Engineering Land Use Application Review Comments

To: Eric Rutledge, Associate Planner, Planning Department
 From: Bob Galati, P.E., City Engineer, Engineering Department
 Project: Willamette Water Supply System Water Treatment Plant
 Site Plan Review, Conditional Use (LU 2020-019)
 Date: November 30, 2020 (Amended December 8, 2020)

SHEET	
DWG	03-GR-30001
DATE	DECEMBER 2020
PROJ	WTP_1.0

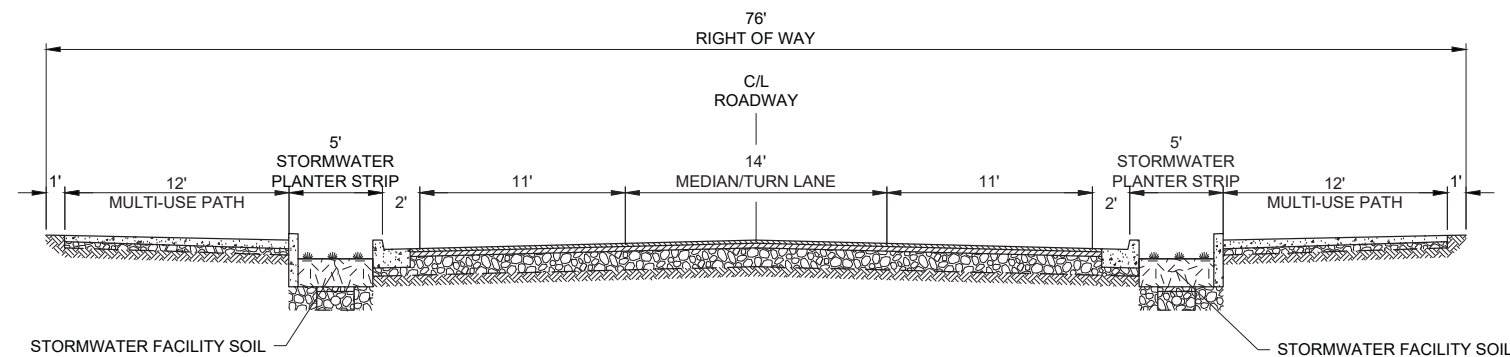
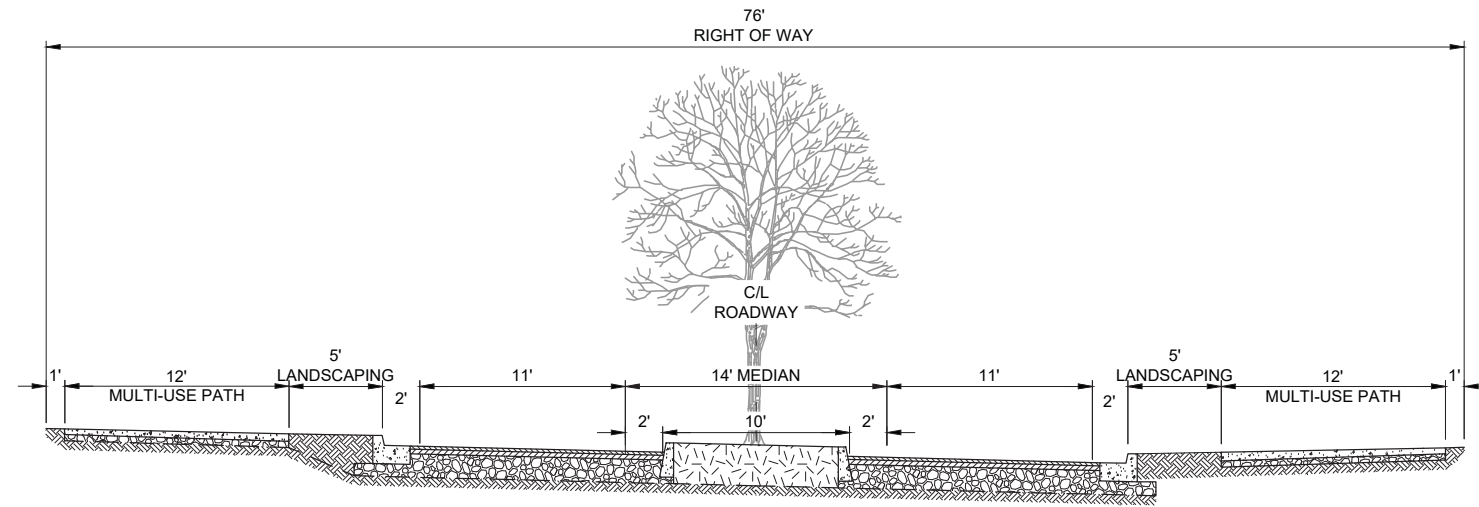
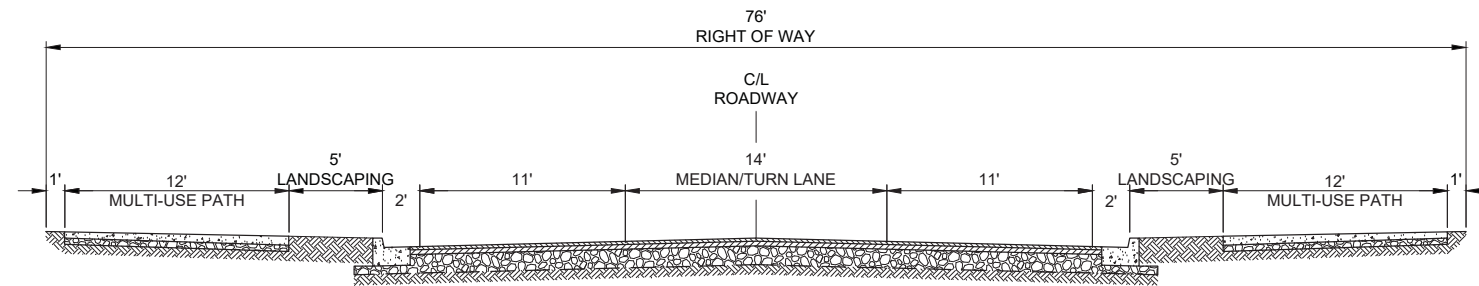
The applicant has submitted a 76-foot road right-of-way section for SW Orr Drive that consists of the following design elements:

- a) Two 13-foot wide travel lanes (11-foot drive lane with 2-foot shy distance)

- b) One 14-foot wide median/turn lane
- c) Two 5-foot wide planter strips
- d) Two 12-foot wide multiuse paths
- e) Two 1-foot clear zone at back of sidewalks

The proposed SW Orr Drive right-of-way section is a deviation from City standards. Deviation from City standards may be approved by submittal/acceptance of a design modification request to the City Engineer. A design modification request must be made for each individual design item that does not conform with City standards. Each design modification request will be reviewed/approved on a case by case basis by the City Engineer.

The applicant has submitted a Design Modification Request form associated with the proposed section. The City Engineer has reviewed the proposed request and has signed off on the Design Modification Request for the SW Orr Drive street section. The approved Design Modification Request is attached to these Review Comments (see attached Exhibit 2).

CONDITION: Prior to Approval of Engineering Public Improvement Plans, applicant shall have dedicated 76-foot right-of-way for SW Orr Drive in conformance with the proposed section submitted as a Design Modification Request, reviewed and approved by the City Engineer (see attached Exhibit 2).

TYPICAL SECTION 1
SW 124TH AVENUE - HALF-STREET IMPROVEMENTS
 SOUTH OF ORR ROAD AND NORTH OF EXISTING RETAINING WALL
 (LOOKING SOUTH)

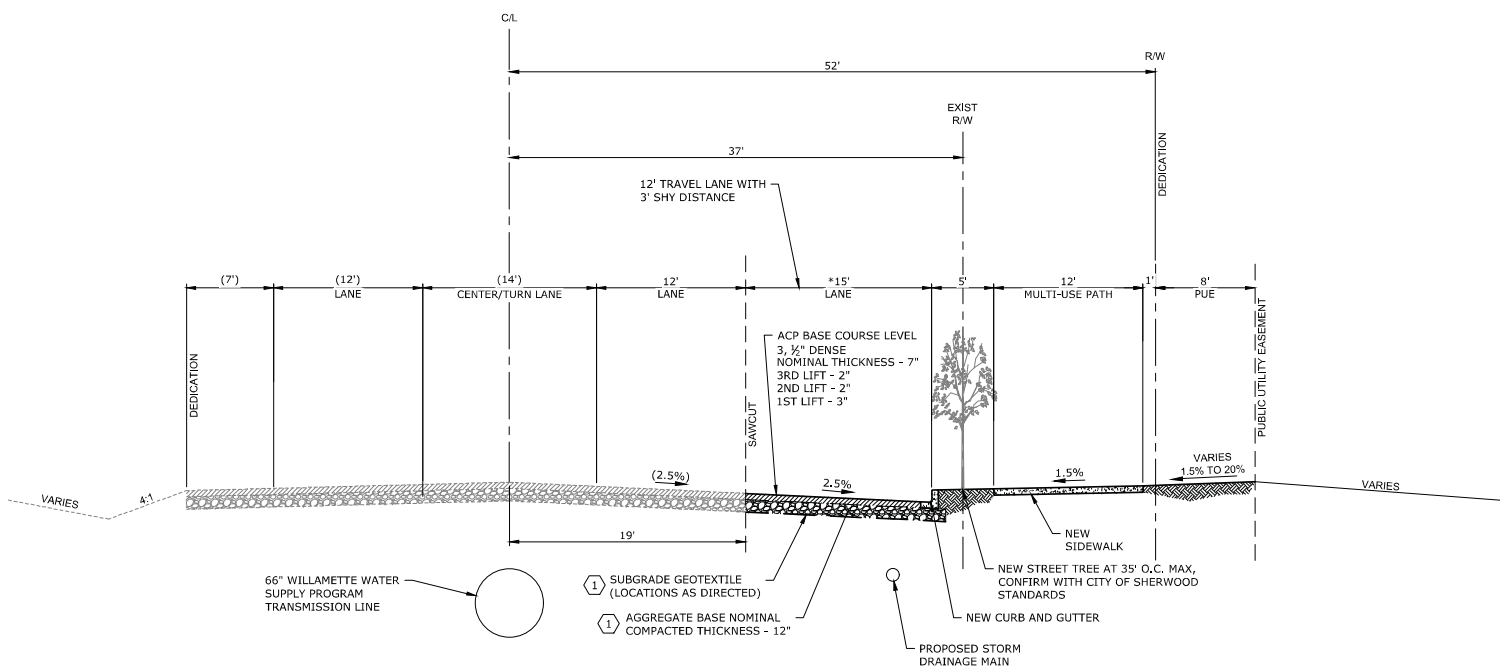
- 1) Requiring half street improvements for a 5-lane arterial with turn lanes along the entire frontage with SW 124th Avenue meeting County standards, including:
 - a. Half-width pavement for a left turn lane
 - b. Dual through lanes
 - c. Curb & gutter
 - d. A 5-foot wide planter strip
 - e. A 12-foot wide multi-use path
 - f. Continuous street lighting.
- 2) Right-of-way dedication of 52-feet from the existing SW 124th Avenue road centerline, including adequate corner radius at the intersection with SW Orr Drive.

The City will be requiring frontage improvements along the SW 124th Avenue frontage, which will include the following items:

- a. An 12-foot wide concrete sidewalk
- b. A 5-foot wide planter strip, measured between street face of curb and street face edge of sidewalk
- c. Street trees, with approved root barriers
- d. Planter strip ground cover plantings

- e. Planter strip irrigation system (including controller, valves and sprinklers)
- f. Street lighting system

CONDITION: Prior to Approval of Engineering Public Improvement Plans, construction plans shall include City required frontage improvements along SW 124th Avenue consistent with City standards as follows:

- a) An 12-foot wide concrete sidewalk & ADA ramps (if needed)
- b) A 5-foot wide planter strip, measured between street side face of curb and street side edge of sidewalk.
- c) Street trees, with approved root barrier
- d) Planter strip ground cover plantings
- e) Planter strip irrigation system, including controller, electronically controlled valves, piping and sprinkler heads
- f) Street lighting system
